**RECALL CAMPAIGN
INSTRUCTIONS**

REF. NO. C24100088

**CHECK THE TORQUE OF THE SCREWS
(BOLTS) AND THE INSTALLATION OF THE
RELATIVE SUPPORT PLATES OF THE
DRIVESHAFTS (AXLE) TO THE GEARBOX**

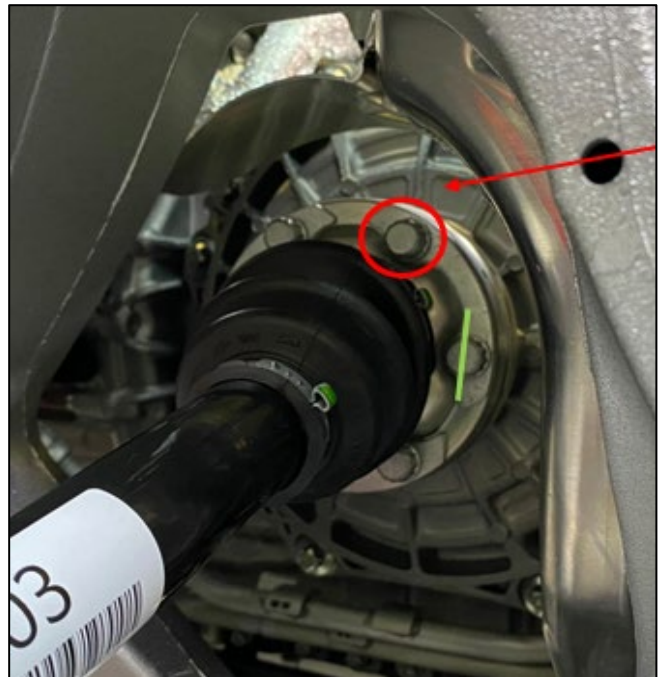
- Place the vehicle on a hoist with a locked gearbox (park lock active) to avoid rotation of the wheels.
- Mark with a marker (green in the picture) the alignment of the screws (bolts) on the plate to highlight a possible rotation after the check.
- After disassembling the wheels, check the screws (bolts) in the picture (6 on the right driveshaft (axle) and 6 on the left driveshaft (axle)) with a **torque wrench set to 30 Nm** (expected to see an immediate lock of the wrench).
- Check the screws (bolts) again with **the torque wrench set at 78 Nm** (expected to see a minimum rotation due to minimal torque loss).

- After the check, measure the rotation of the mark on the screw (bolt) compared to the plate.
- Please record the data from the torque wrench used and the date of the last torque wrench calibration.
- If during the first check at **30 Nm** a rotation of the screws (bolts) is noticed, **it means that the component has not been assembled correctly and may be damaged.**
In this case, open a ROL relating to the damaged components and wait for instructions.
- If during the second check at **78 Nm** a rotation of the screws (bolts) is noticed (**but no rotation at 30 Nm**), it is allowed to **tighten the screws (bolts) to the correct torque. No replacement is needed.**
